**Draft revision to the approved baseline and monitoring methodology AM0053****“Biogenic methane injection to a natural gas distribution grid”****I. SOURCE AND APPLICABILITY****Source**

Version	Date	Nature of revision(s)
04.0.0	21 September 2012	EB 69, Annex # Revision to: <ul style="list-style-type: none"> <li>Expand the applicability of the methodology to conditions where membrane CO<sub>2</sub> removal technology is used under the project activity;</li> <li>Clarify that estimation of the project emissions from the electricity consumption by applying the “Tool to calculate baseline, project and/or leakage emissions from electricity consumption” is allowed;</li> <li>Provide additional guidance on how the methodology can be used in conjunction with ACM0014;</li> <li>Include other editorial improvements.</li> </ul>

Figure 5: Schematic of membrane gas separation<sup>5</sup>

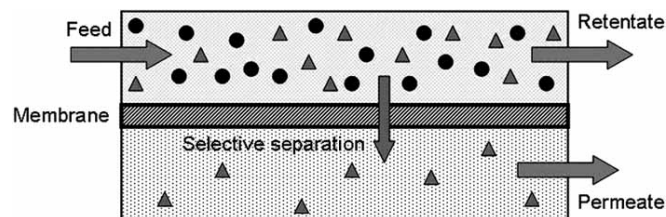
Membranes act as filters to separate one or more gases from a feed mixture and generate a specific gas rich permeate, as shown in Figure 5. Two characteristics dictate membrane performance, permeability; that is the flux of a specific gas through the membrane, and selectivity; the membrane's preference to pass one gas species and not another. There are five possible mechanisms for membrane separation; Knudson diffusion, molecular sieving, solution-diffusion separation, surface diffusion and capillary condensation.

This technology enables an efficient CO<sub>2</sub> removal from the biogas flux leaving a richer CH<sub>4</sub> retentate with similar CH<sub>4</sub> composition as Natural Gas.
